February 9, 2023

**C-22-14
109R & 131 CLARK LANE
PUBLIC HEARING
EXHIBIT # 48**

**RE: Kingstown Properties, LLC – Affordable Housing Development – Clark Lane
P&R Job No. 213009**

Project:
**STANDARD DETAIL
BIORETENTION ISR**
STORMWATER SYSTEM

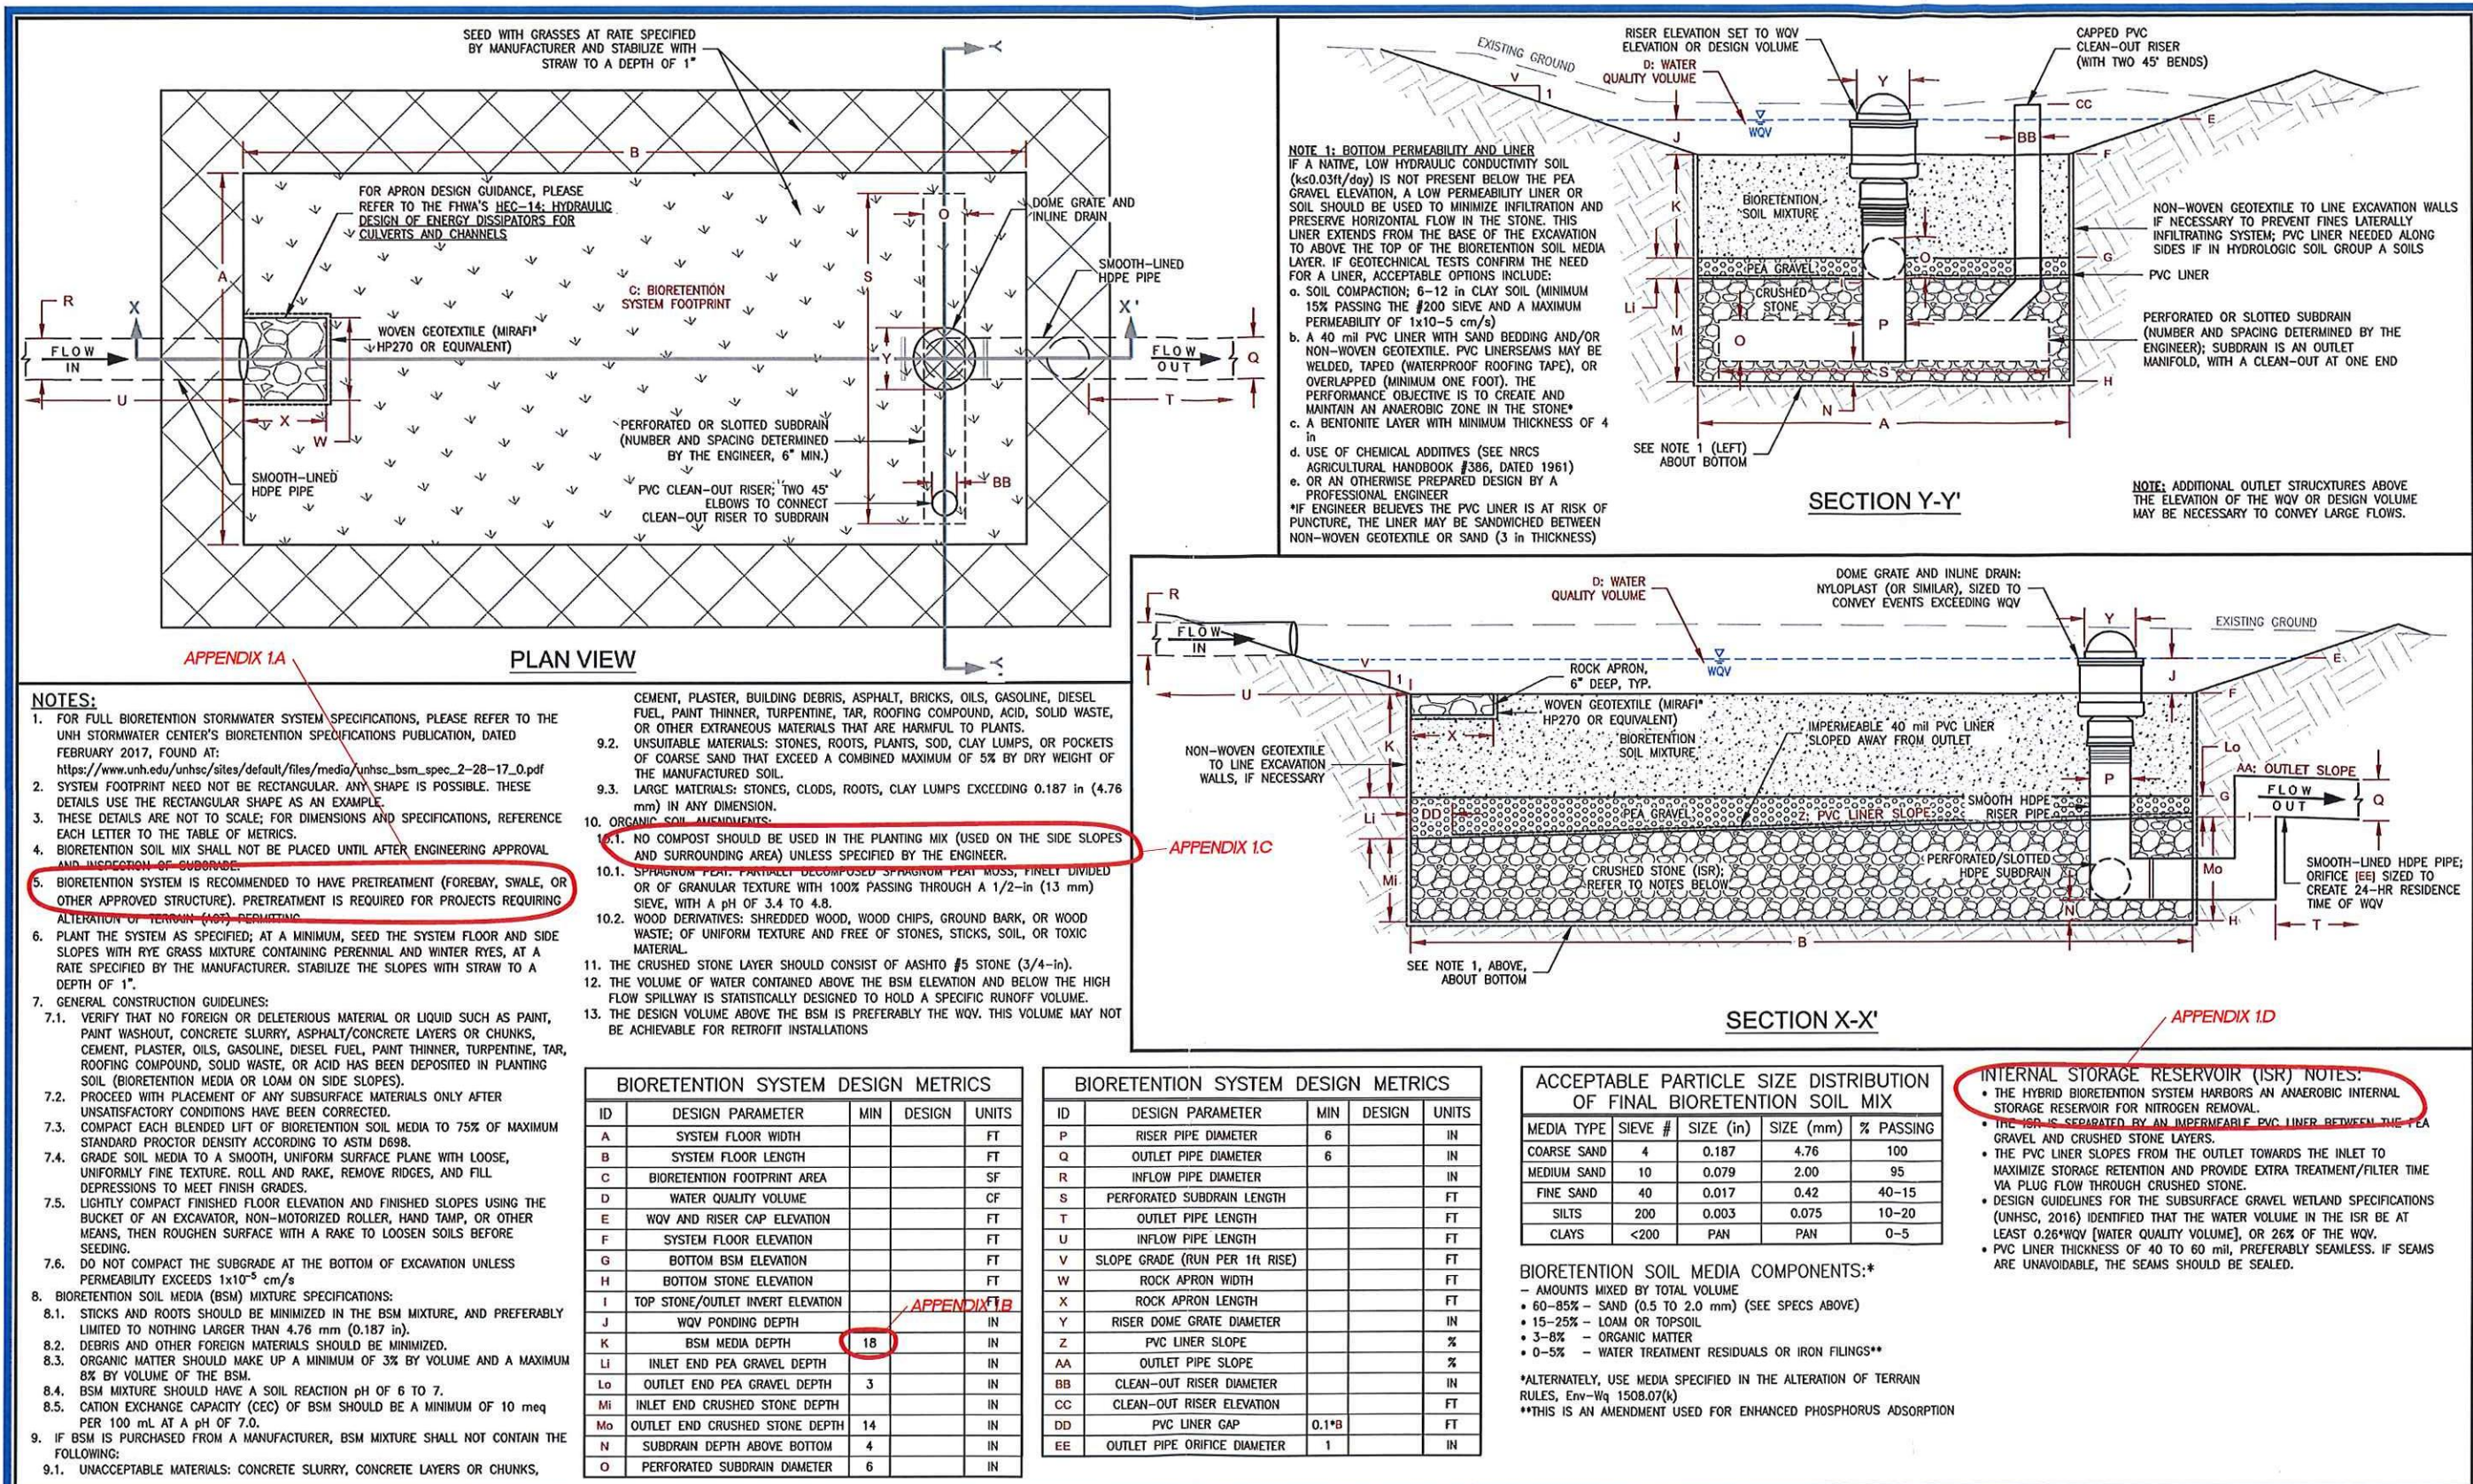
4. Ms. Gadwa provides a detailed critique of the bioretention basin design in Appendix 1 of her report. It appears that this critique is based primarily on outdated information from 2009 and 2012 from the UNH SWC and a lack of understanding of how the system will function. The proposed design is based on 2020 criteria provided by the UNH SWC which differ from the older criteria. A typical detail for the enhanced bioretention basin prepared by the UNH SWC is attached and annotated to specifically address the concerns raised by Ms. Gadwa. The following corresponds to each specific comment:

- A. Pretreatment is provided by the Stormceptor unit, however we take no exception to the addition of a forebay to capture additional sediment.
- B. The 18" thick media layer conforms with the 2020 UNH SWC standard detail. The basin is designed to provide a minimum residence time of 24 hours in the subsurface ISR system.

- C. The media mix proposed conforms with the 2020 UNH SWC requirements which specifically state that compost should *not* be used in the filter media.

- D. The ISR system below the basin filter media specifically requires anaerobic (saturated) conditions to function properly. The ISR is essentially a subsurface gravel wetland which offers a second stage of treatment below the biofiltration bed.

- E. Given that Ms. Gadwa is not an engineer, there may be a lack of understanding of the hydrologic analysis calculations and the design and function of the water quality diversion weir manhole. This structure has been designed specifically to avoid excessive flows through the bioretention basin even during large storm events by limiting headwater depths on the 12" CPP pipe to the bioretention basin by maximizing the length of the overflow weir. The weir elevation corresponds to the headwater elevation at which the water quality flow (WQF) is reached and because of the weir length, the headwater does not increase significantly during large storm events.

- F. The bioretention basin underdrain will not have an adverse impact on the hydrologic regime of down gradient wetlands.
